HISTORIC PRESERVATION BOARD

AGENDA

HISTORIC PRESERVATION BOARD MEETING

- i. Certificate of Appropriateness for Exterior Alterations, Building Addition and Site Alterations; 188 Vaughan Street; Gregg Lipton and Sara Crisp, Applicant.
- ii. Certificate of Appropriateness for Exterior and Site Alterations; 130A Park Street, Lori Price, Applicant.

2 SOUTHERN ELEVATION
SCALE: 1/4" = 1'-0"

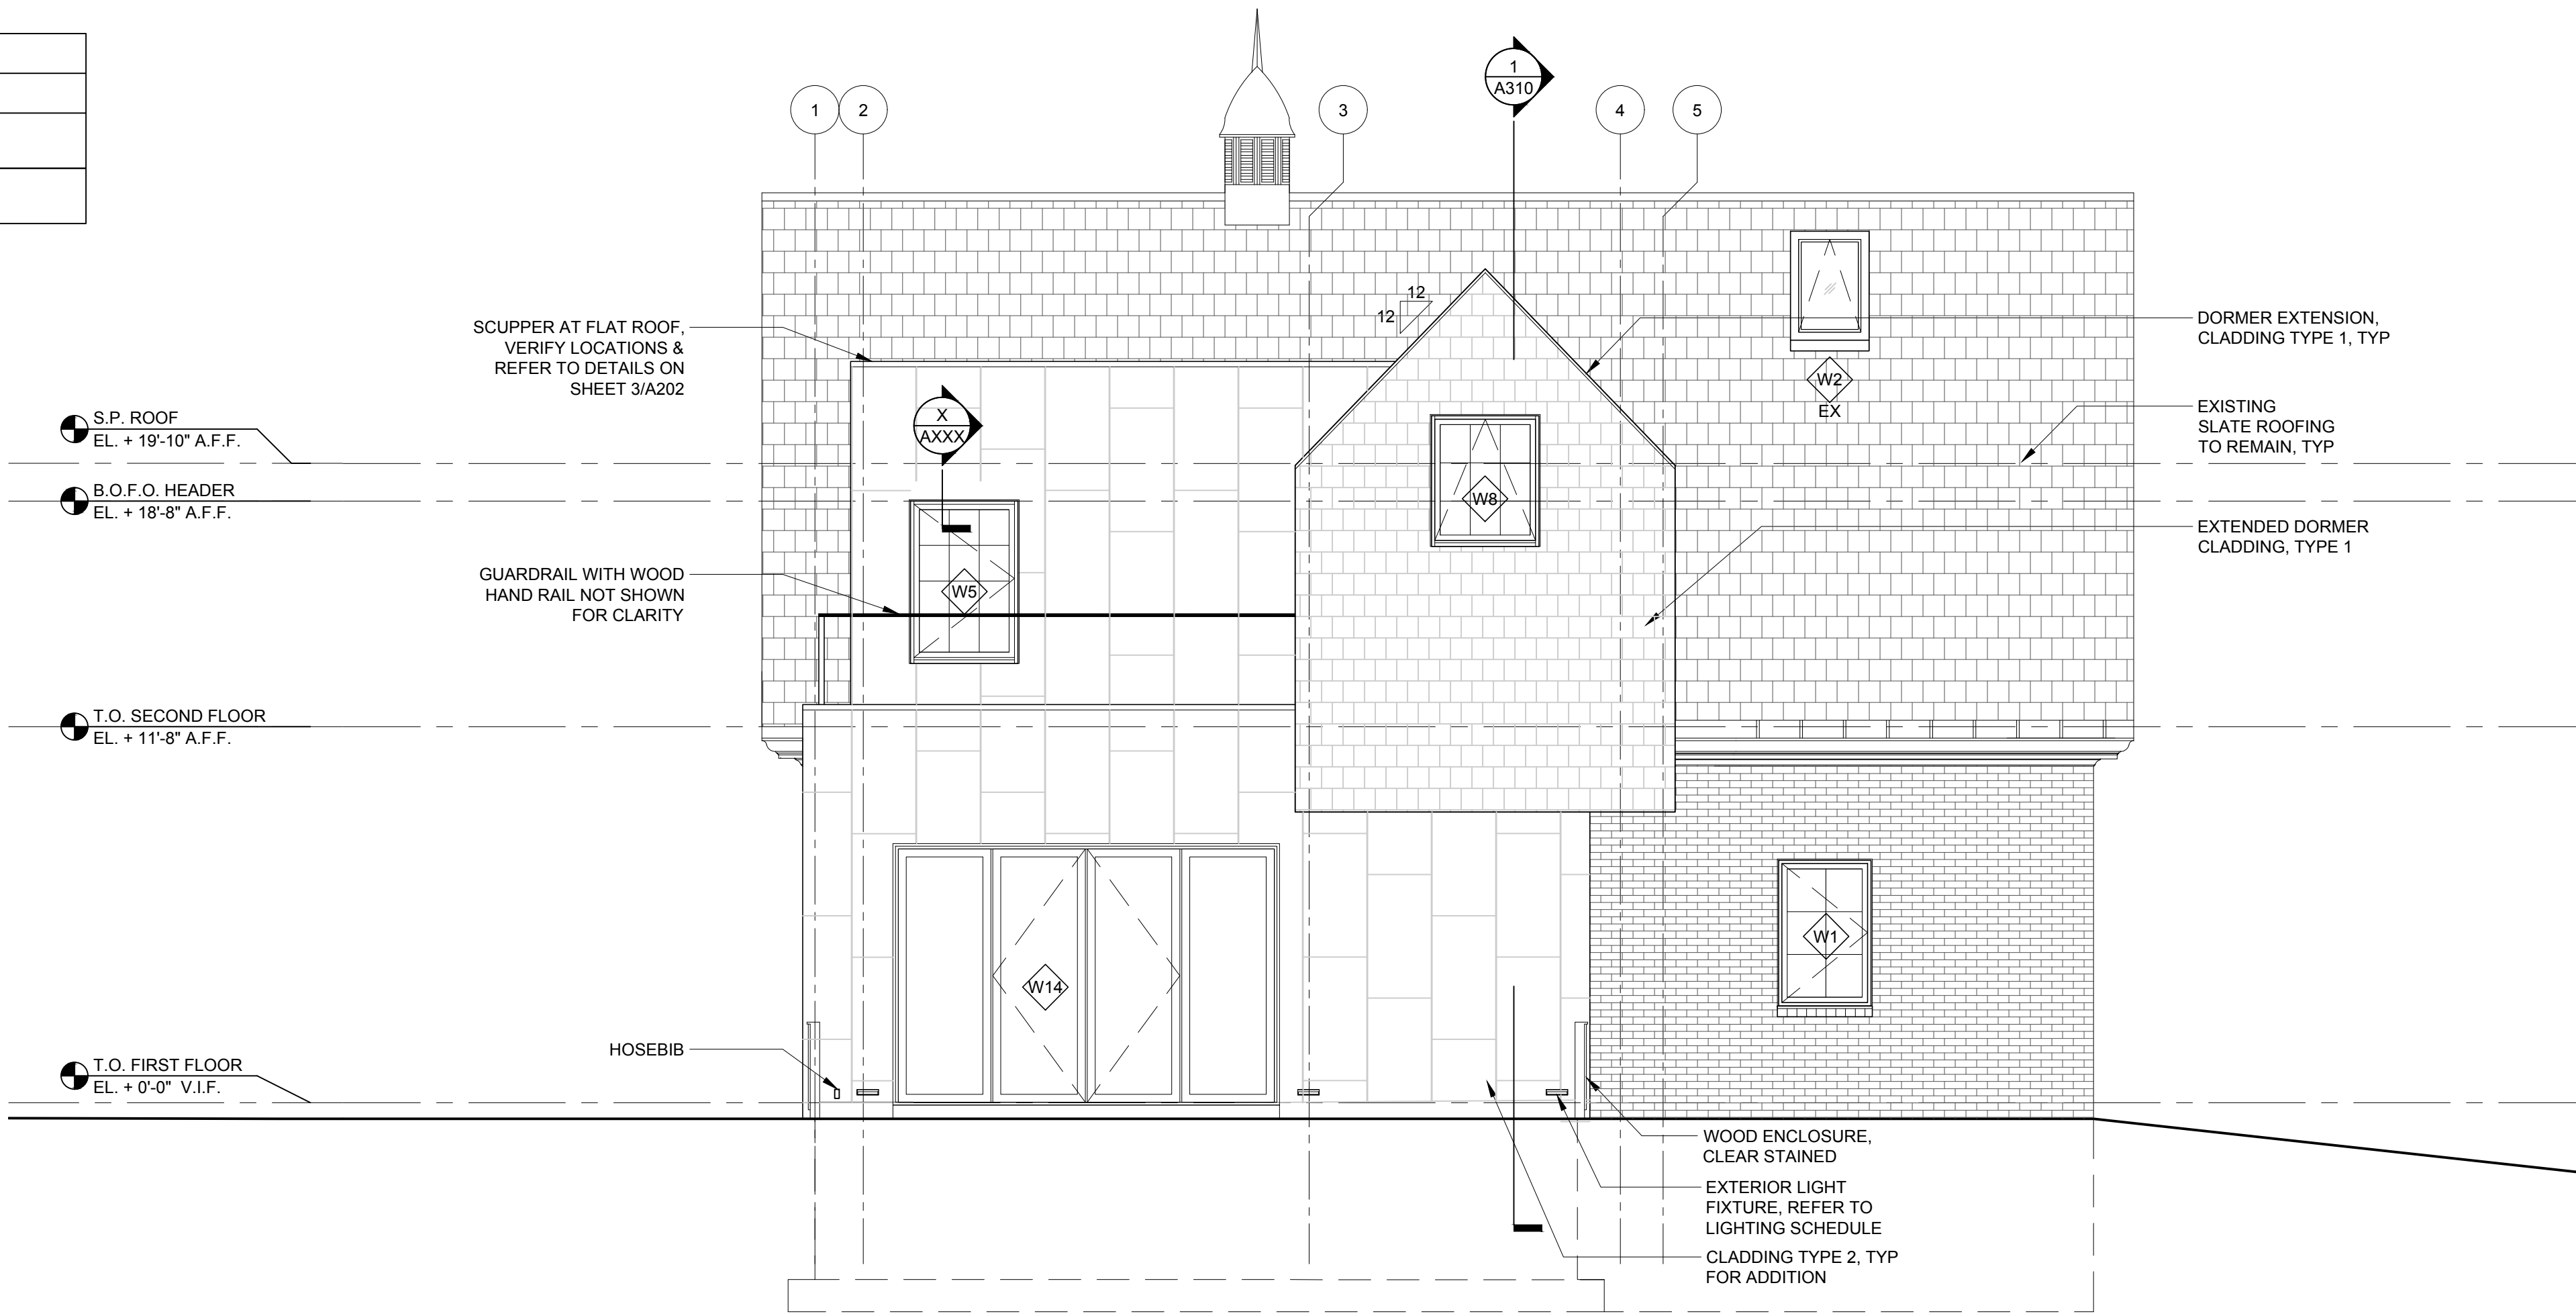
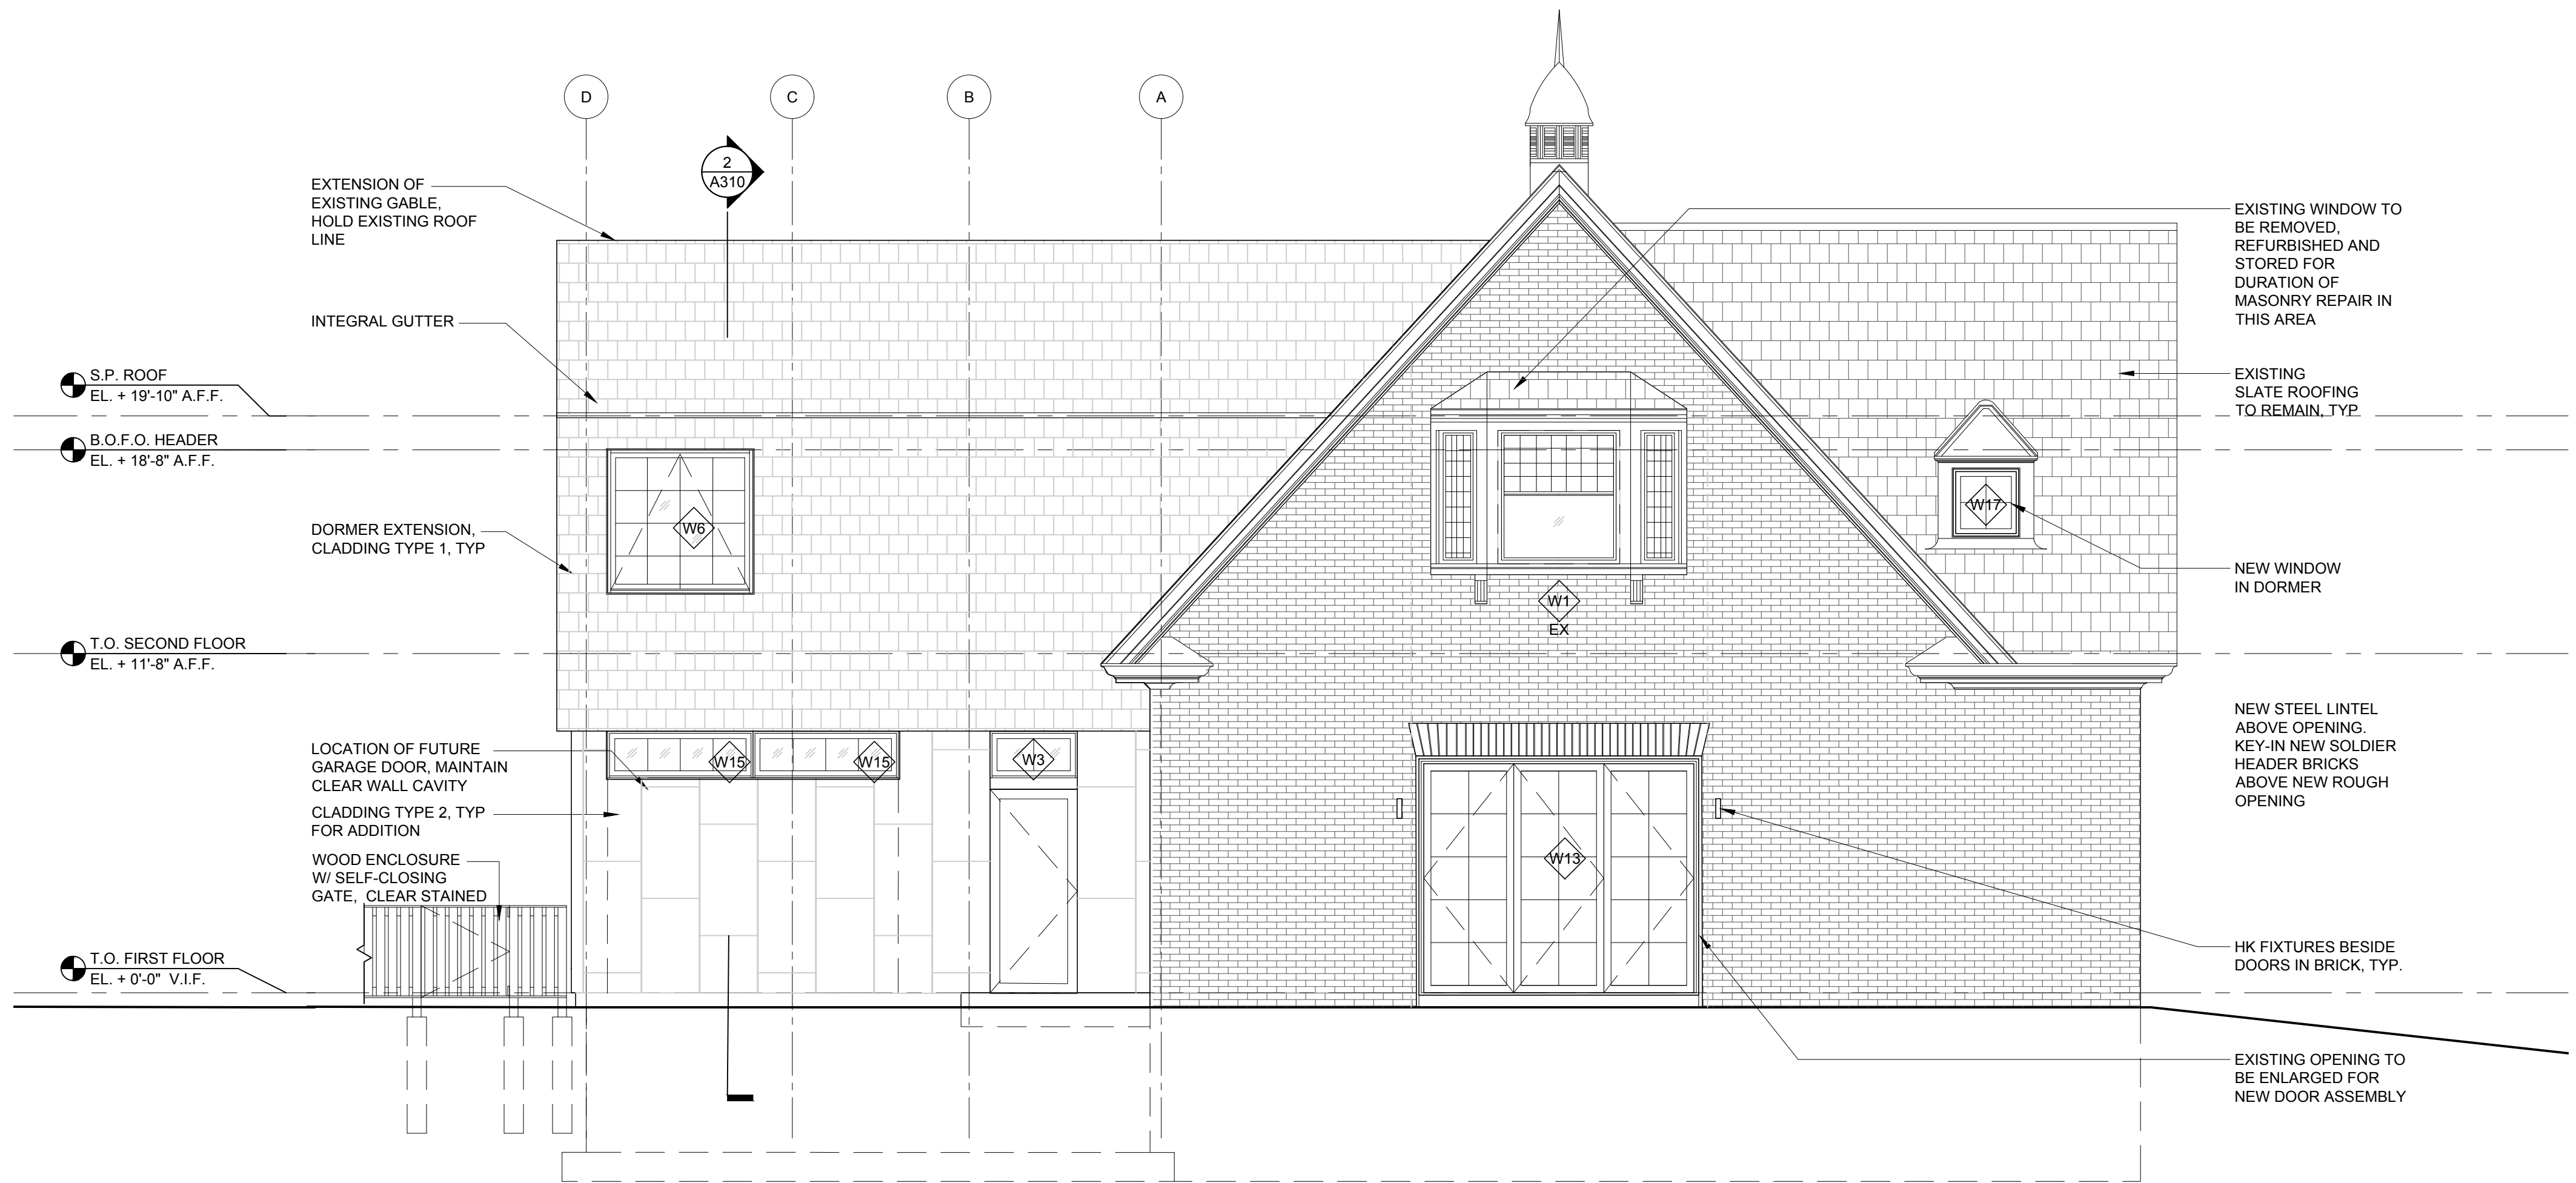
- A divided-lite transom has been added at the ground floor level, above the area where a future garage door opening may be created.
- At the second-floor level, the proportions of the single divided-light window appear to have changed and the "lintel" above the window has been eliminated. The left side of the window aligns with the left end of the transom window below.

As with the original proposal, the window at the second floor-level of the addition is shifted to the far end of the elevation. As shown, the left edge of the window aligns with the corresponding edge of the newly-introduced transom on the ground floor. Now that the transom has been added to the overall façade composition, the question of the position of the second-floor window might warrant further discussion. Is the current alignment appropriate? Should the second-floor window be centered over the transom?

4 **NORTHERN ELEVATION**
SCALE: 1/4" = 1'-0"

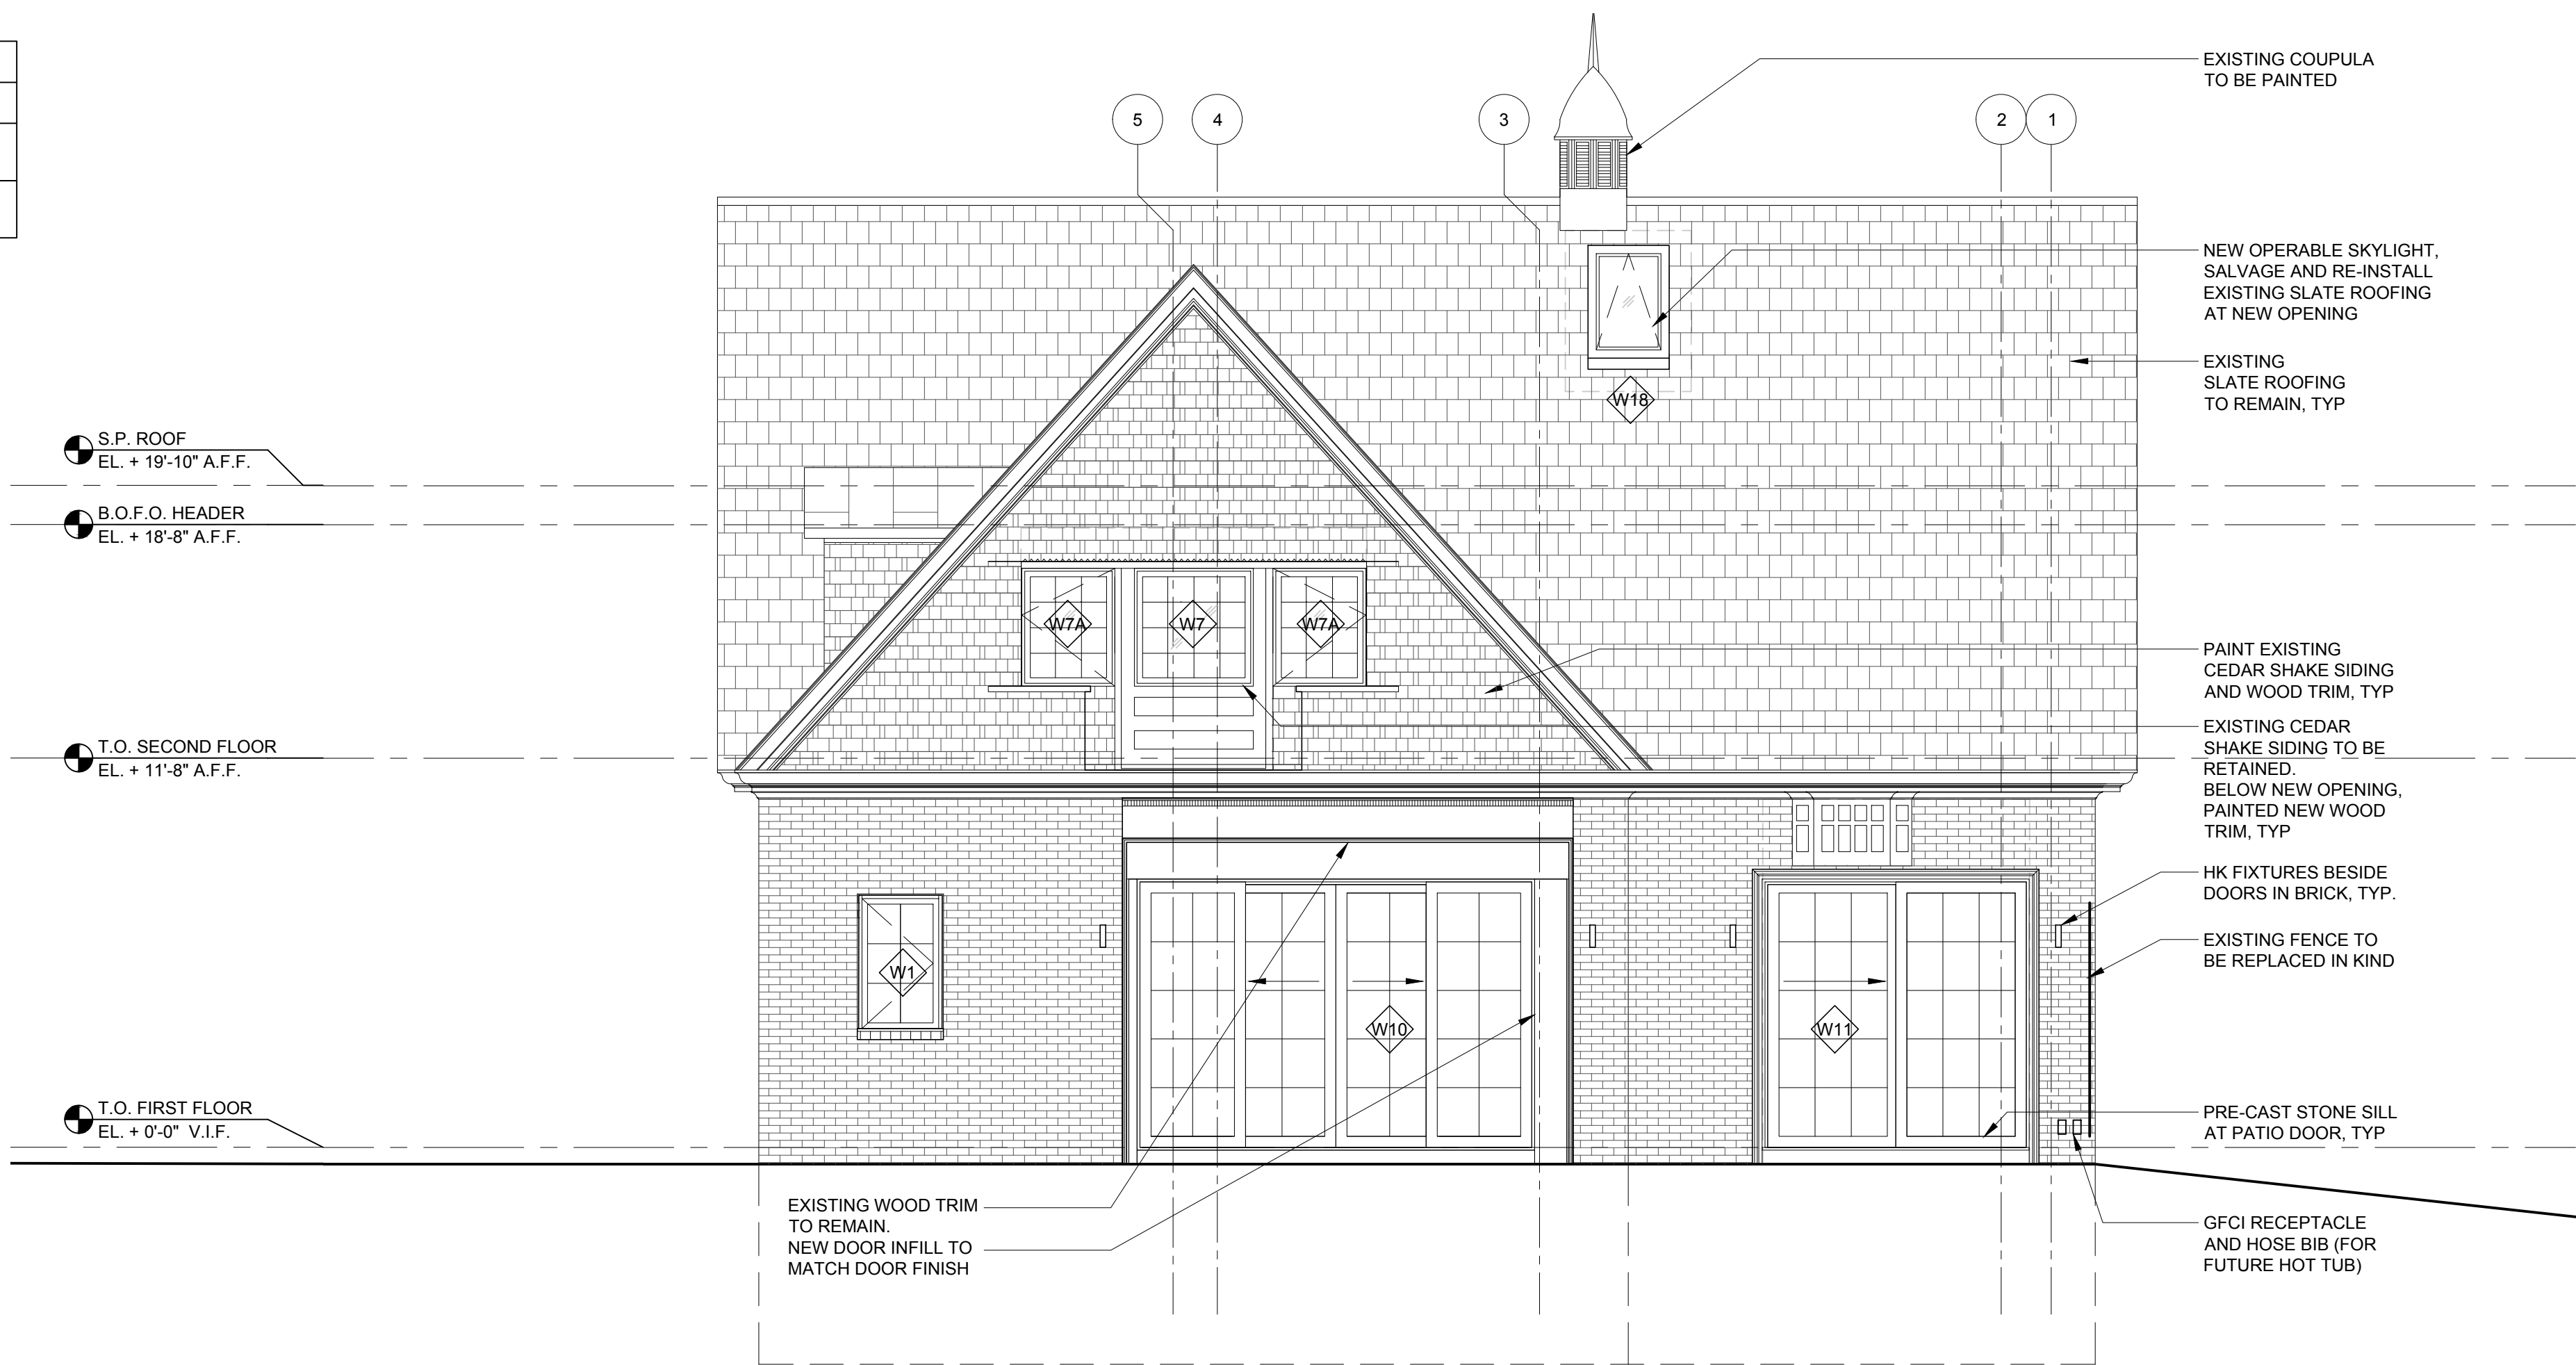
- Transoms above the proposed divided-light doors within the two large ground floor openings have been eliminated. The proportions of the lights within the doors appear to have been adjusted somewhat. The width of the trim on either side of the larger opening has also been adjusted in the drawing to reflect actual conditions.
- The single window at the ground floor level is now shown as a divided-light casement.
- The window treatment within the second-floor gable has been modified. Horizontal panels have been added beneath the new center window to more closely resemble the large door opening that was originally located in this position.
